9.4 Air Conditioning, Heating, Cooling and Ventilating Systems

The information in this section of the reference ABWR DCD, including all subsections, tables, and figures is incorporated by reference with the following departures and supplements.

Figure 9.4-2c Turbine Building Electrical Equipment Areas (EEA) HVAC System Diagram

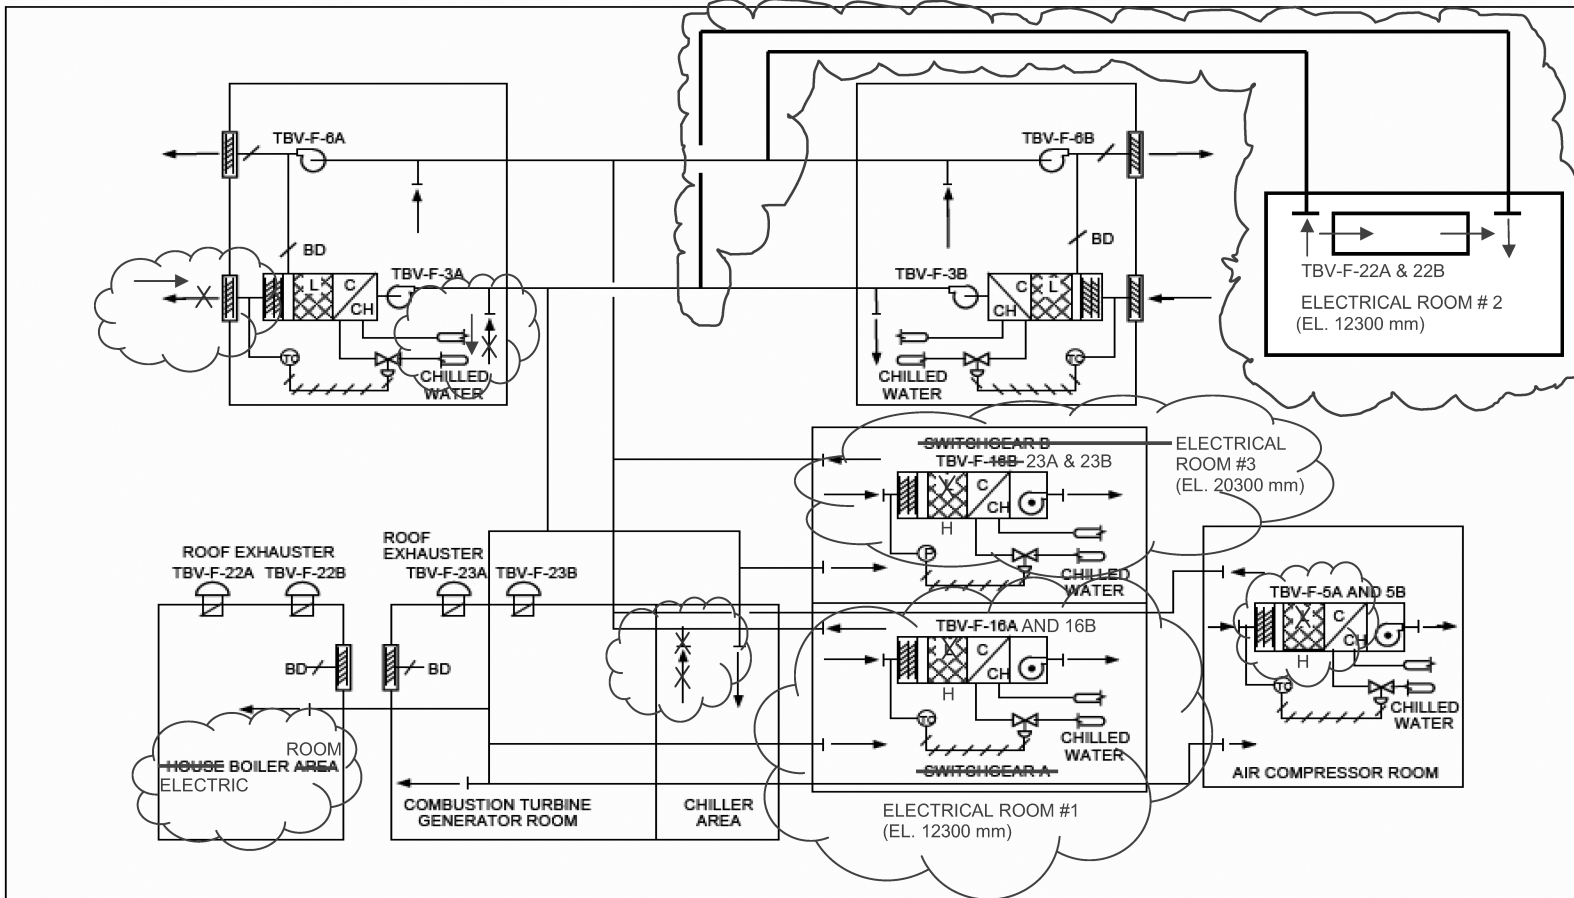
STD DEP 9.4-4 (Tables 9.4-3, 9.4-5, 9.4-5a, 9.4-5b, 9.4-5c, and 9.4-5d), (Figures 9.4-2a, 9.4-2b Sheet 2, and 9.4-2c)

9.4.4.2.2 ~~E/B~~ EEA HVAC General Description

STD DEP 9.4-4

The ~~E/B~~ EEA HVAC schematic diagram is shown on Figure 9.4-2c.

The Electrical ~~Building~~ Equipment area HVAC System is provided with two 100% capacity air supply fans and two 100% capacity exhaust fans.

The air supply fan draws outside air through louvers, control dampers, low efficiency filters, electrical heating coils, and chilled water coils, and discharges air directly into the ~~switchgear~~ electrical rooms, chiller, combustion turbine generator, house electric boiler room and air compressor rooms. Return air Ductwork ductwork and bypass dampers are is provided to allow recirculation of air from the ~~switchgear~~ electrical rooms and chiller rooms air compressor room.

The ~~E/B~~ EEA HVAC system maintains the Electrical ~~Building~~ Equipment Areas at a positive pressure with respect to atmosphere.
